MIL-C-48610B(AR)
AMENDMENT 1
12 July 1993

CIRCUIT CARD ASSEMBLY: 11746908, LOW VOLTAGE POWER SUPPLY CONTROL LOGIC

This amendment forms a part of MIL-C-48610B(AR), dated 30 June 1981, and is approved for use by the U.S. Army Armament, Munitions, and Chemical Command, Department of the Army, and is available for use by all Departments and Agencies of the Department of Defense.

FIGURE 2. Q-switch drive waveforms.

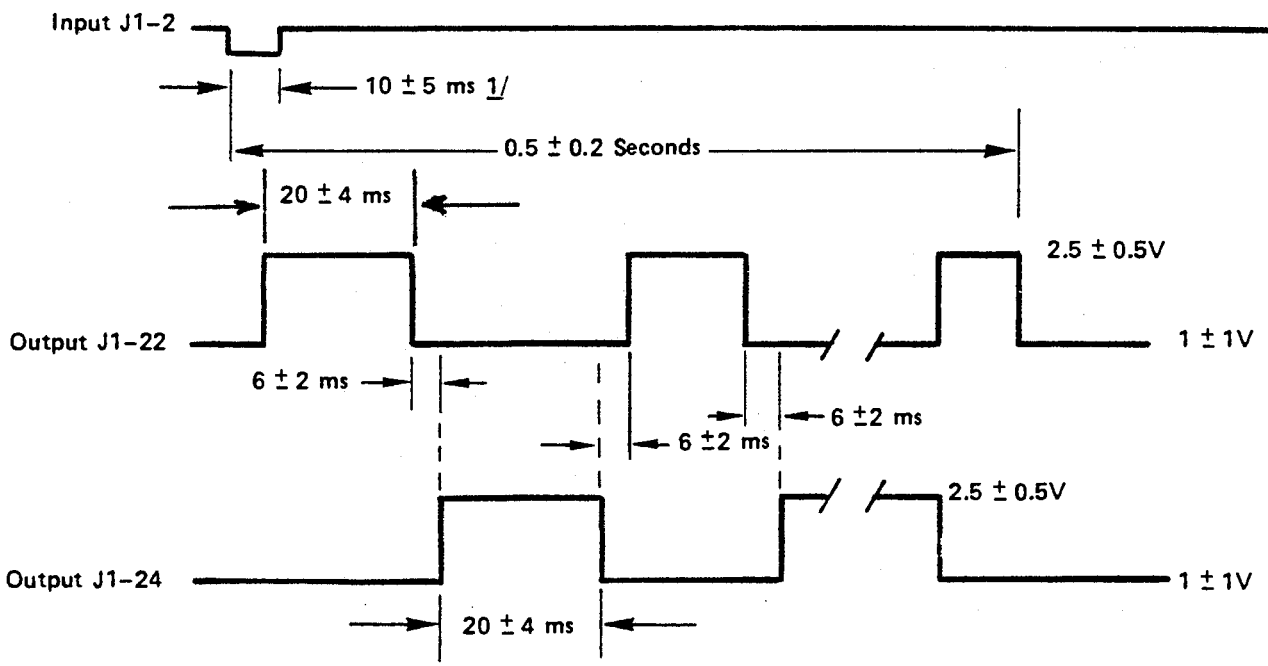
Figure 2: Delete in its entirety and substitute:

1/ Pulse widths and time intervals are specified at 50% of peak pulse amplitude.

FIGURE 3. Sync signal A and B.

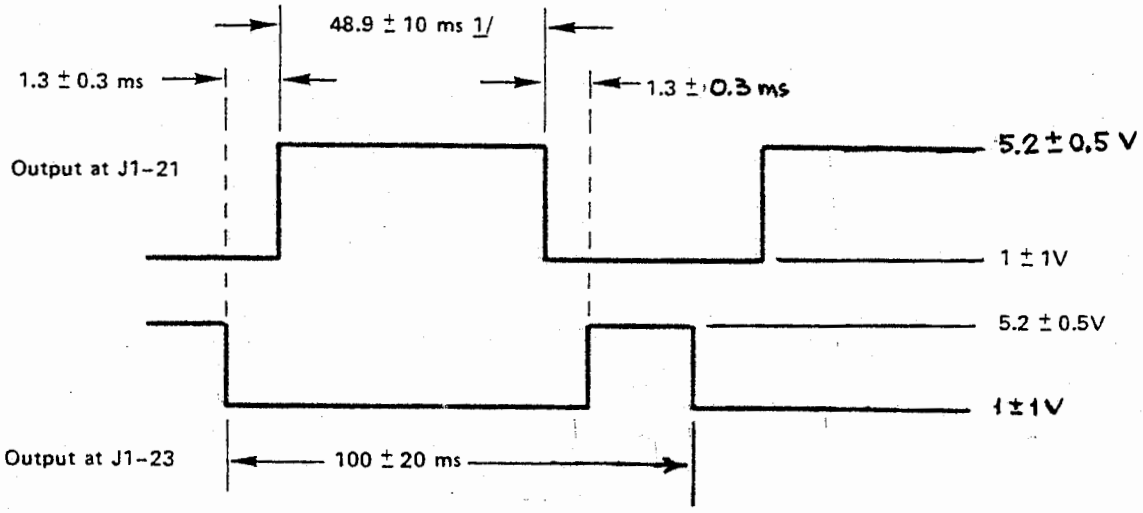
Figure 3: Delete in its entirety and substitute:

1/ Pulse widths and time intervals are specified at 50% of peak pulse amplitude.
